CITY OF FRANKLIN  
PLAN COMMISSION MEETING\*  
FRANKLIN CITY HALL COUNCIL CHAMBERS  
9229 W. LOOMIS ROAD, FRANKLIN, WISCONSIN  
AGENDA  
THURSDAY, MAY 4, 2017, 7:00 P.M.

<b>Project Name:</b>	Interstate Partners Special Use and CSM
<b>Project Address:</b>	O West Oakwood Road (Tax Key No. 951-9994-001)
<b>Applicant:</b>	Caroline Brzezinski, Interstate Partners
<b>Property Owner(s):</b>	JAMS-4 LLC
<b>Current Zoning:</b>	Planned Development District No. 39
<b>2025 Future Land Use:</b>	Business Park
<b>Use of Surrounding Properties:</b>	Single-family residential and Wheaton Franciscan/Ascension Hospital to the north; trucking, areas of natural resource features, and single-family residential to the south; single-family residential and the City of Oak Creek to the east; and agricultural lands to the west
<b>Applicant Action Requested:</b>	Approval of the CSM and Special Use for two light industrial/light manufacturing mixed-use buildings

# PLAN COMMISSION DRAWINGS FOR: INTERSTATE PARTNERS SPECULATIVE INDUSTRIAL BUILDING

**L 1.1**

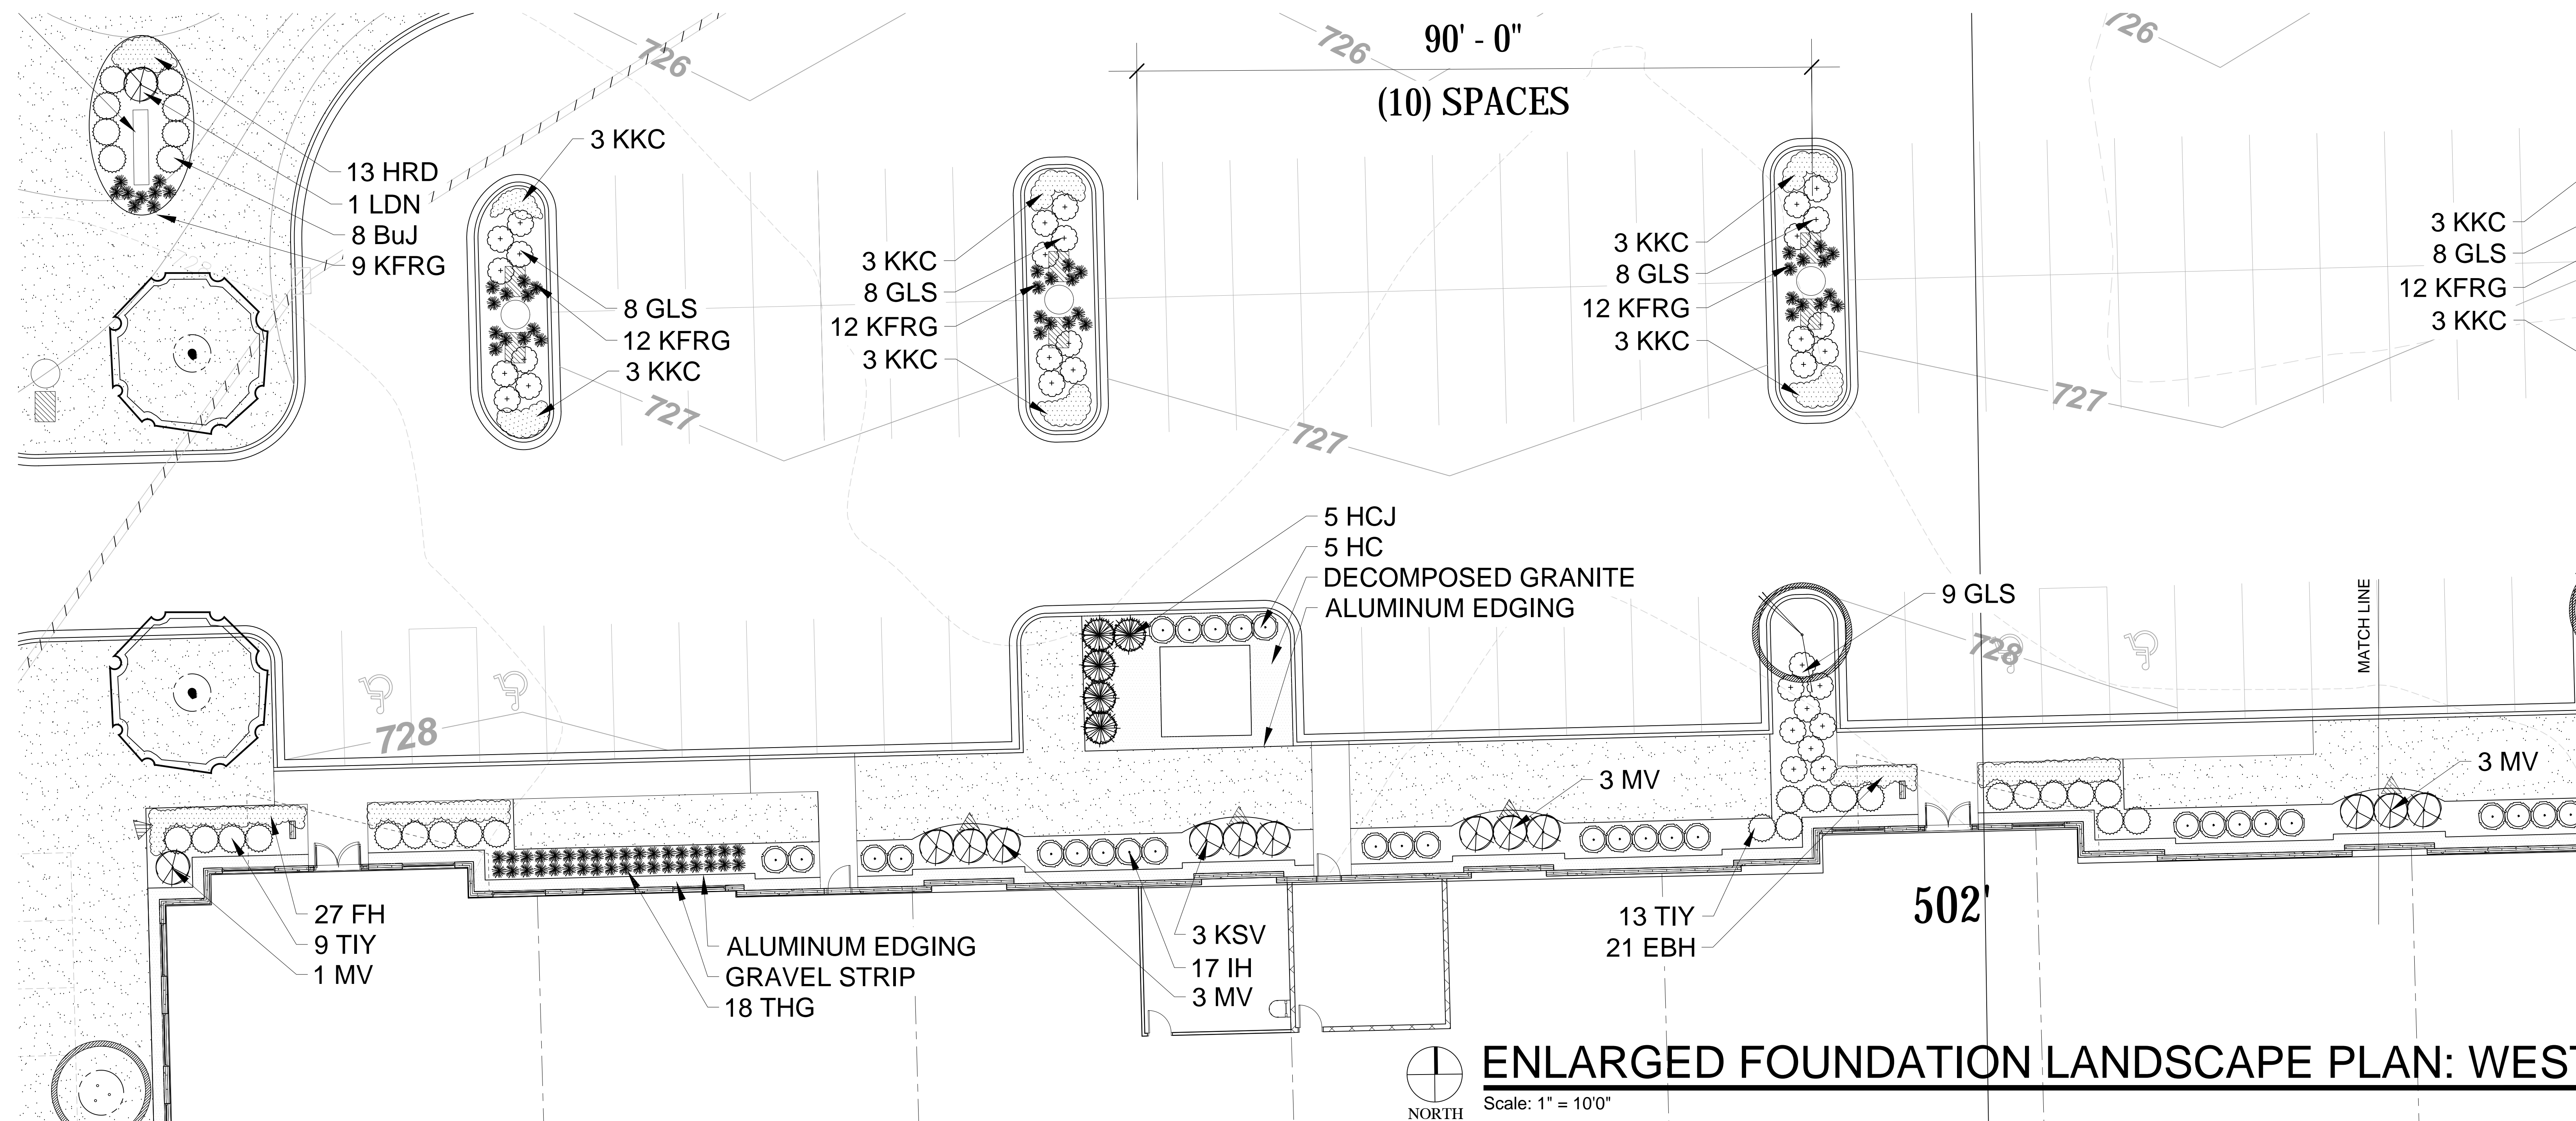
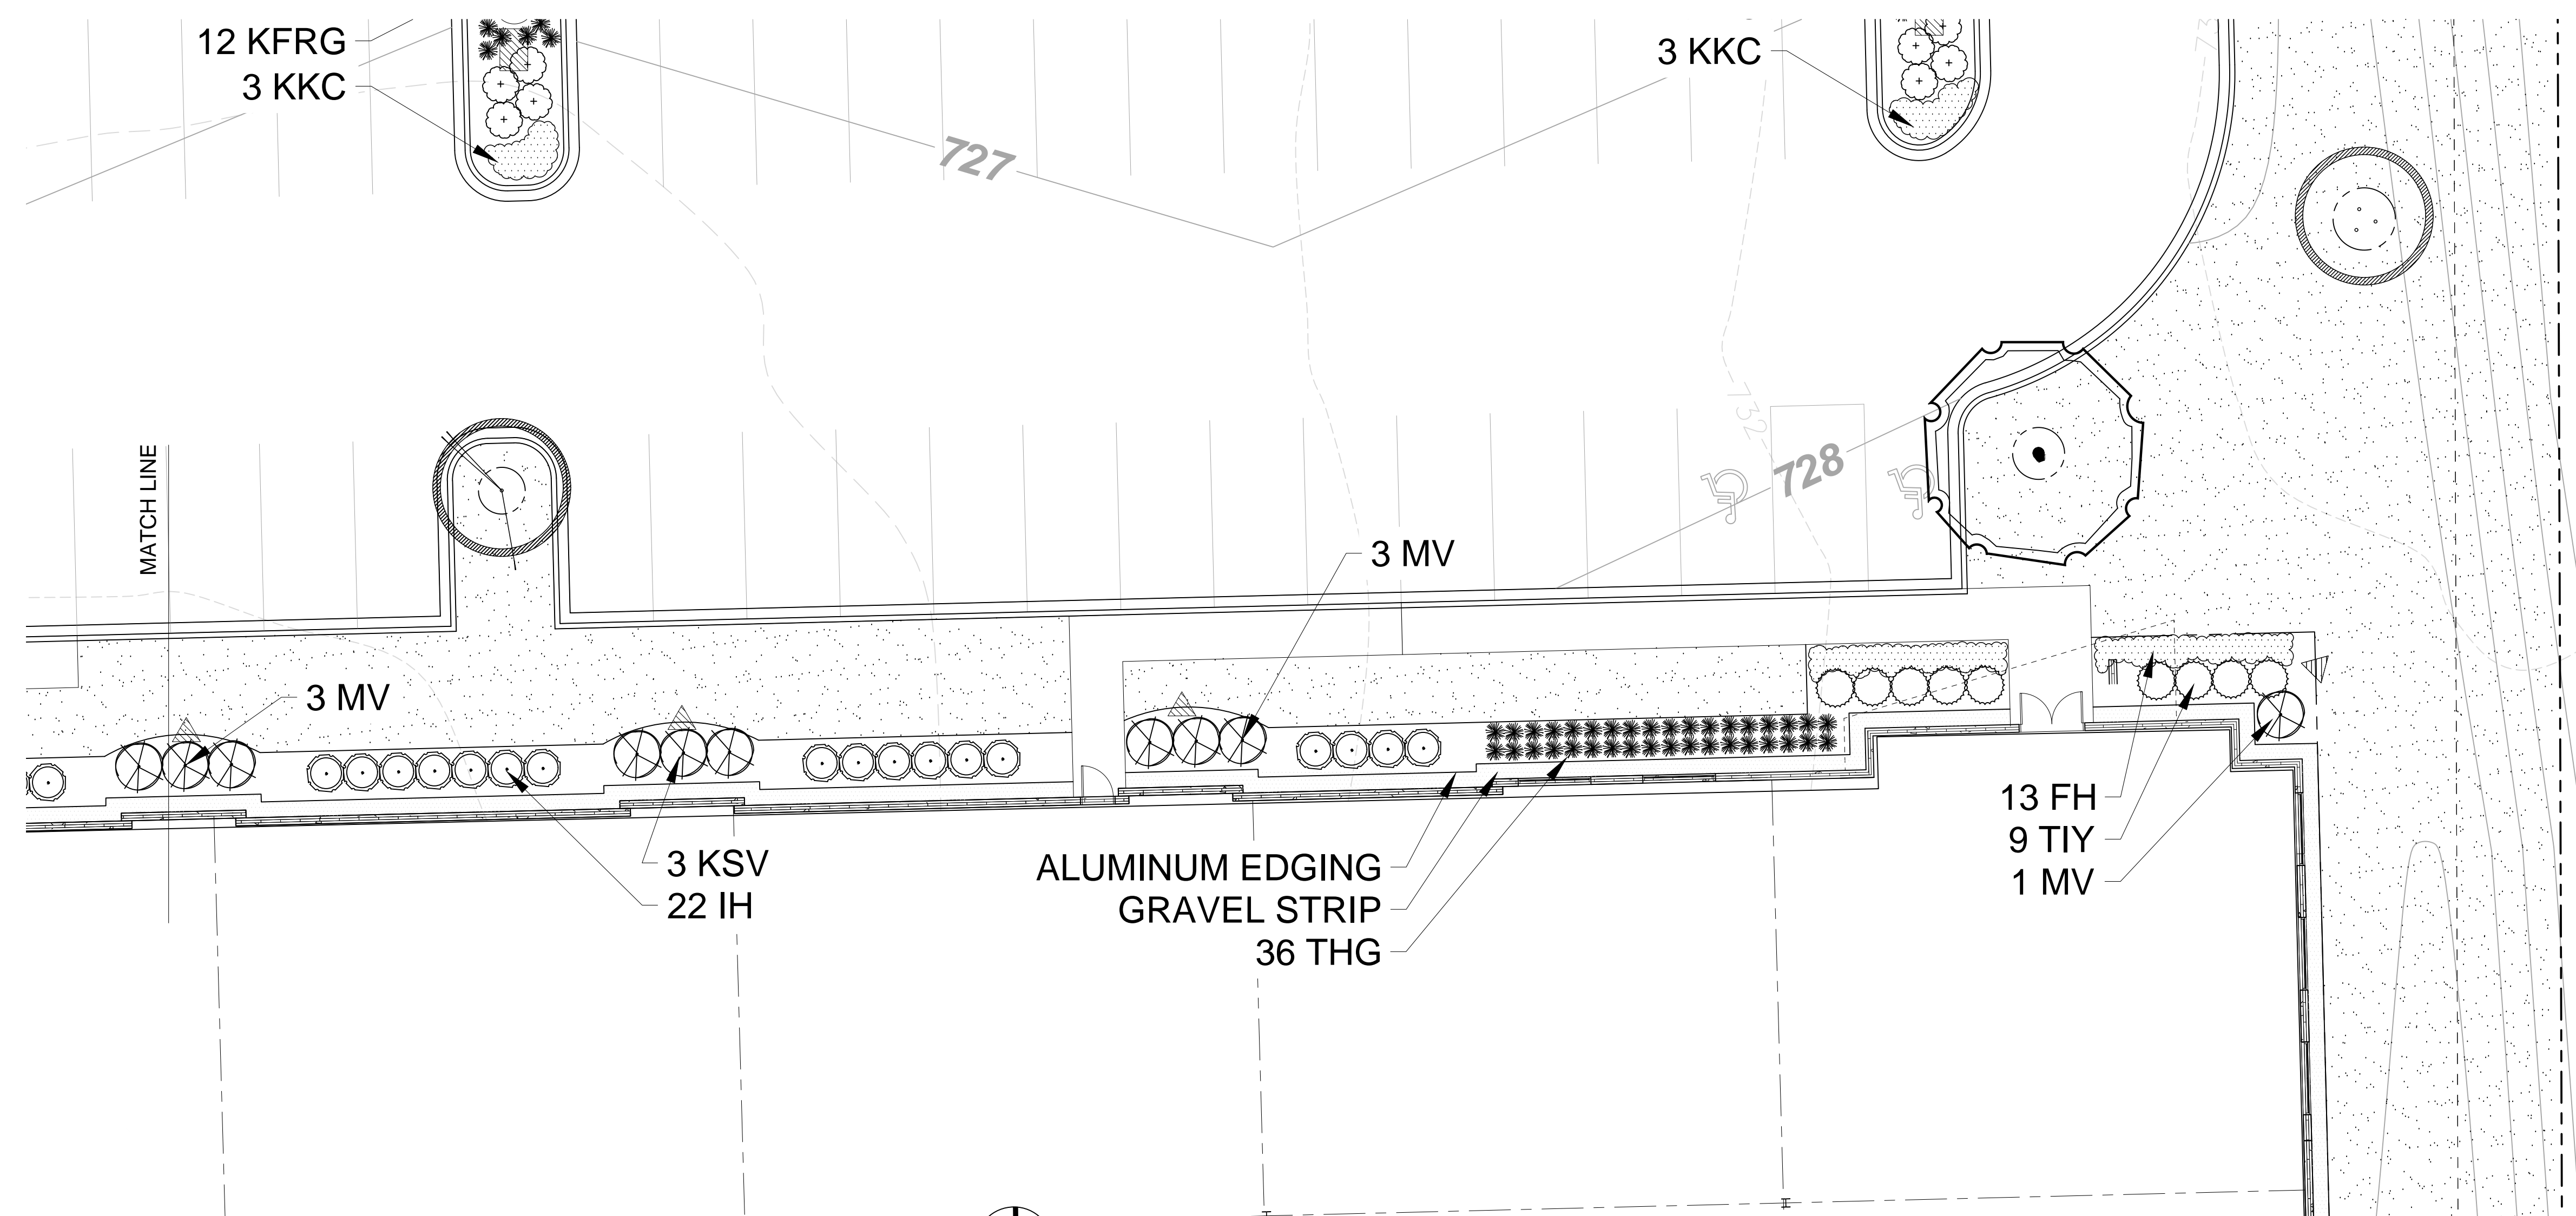
33. The table on Sheet L1.2 indicates 14 MV plantings. Sheet L1.1 illustrates 16 plantings. Please revise to be consistent. *This has been corrected.*
34. Staff recommends plantings within the parking lot islands. Note that staff does not object to mulch or stone being installed, opposed to grass. *This has been addressed on the plans.*

AS100

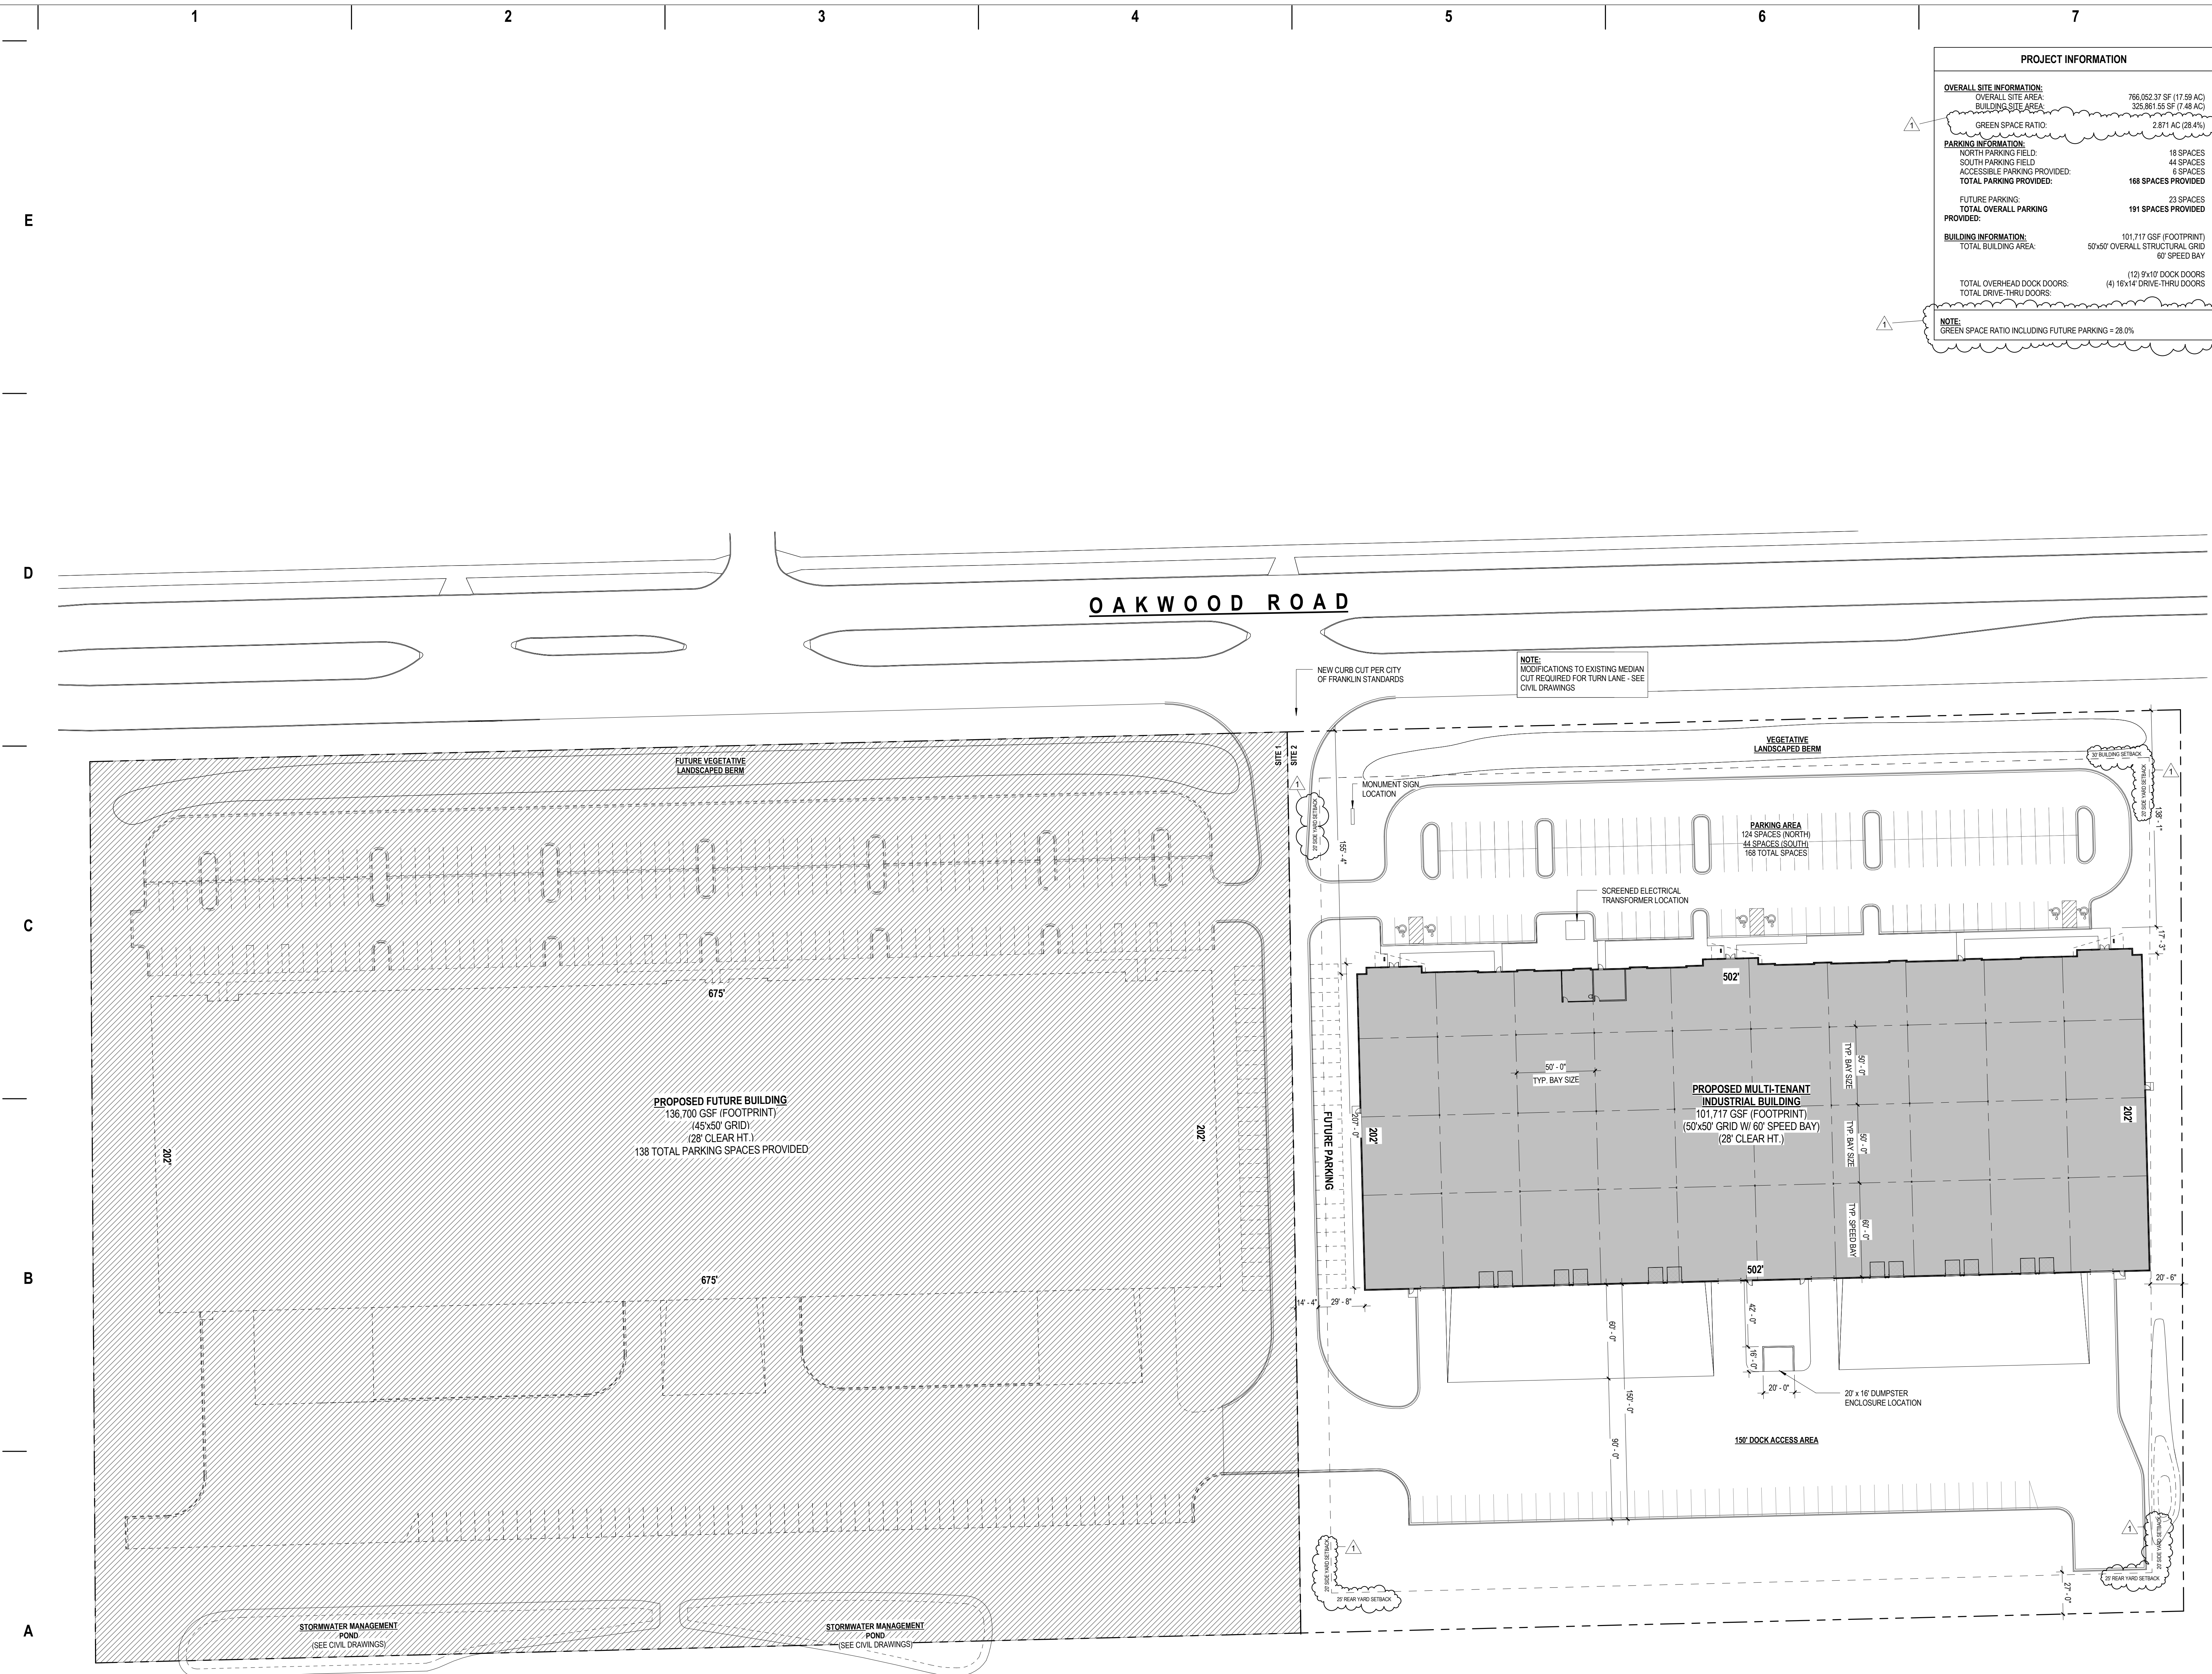
26. The walkways do not match from Sheet AS100 and the landscape plan. Please note that connections to all entrances are recommended. That may just modify the planting count; although the change should not be significant. This has been corrected.

31. Sheet AS100 notes a 20' side yard setback. The side yard setback is 10'. Also, the rear yard setback is 25'. Please review setbacks and make sure they are correct and consistent throughout the plan set. Sheet AS100 shows actual distances, not required setbacks. All distances are in excess of setback requirements.
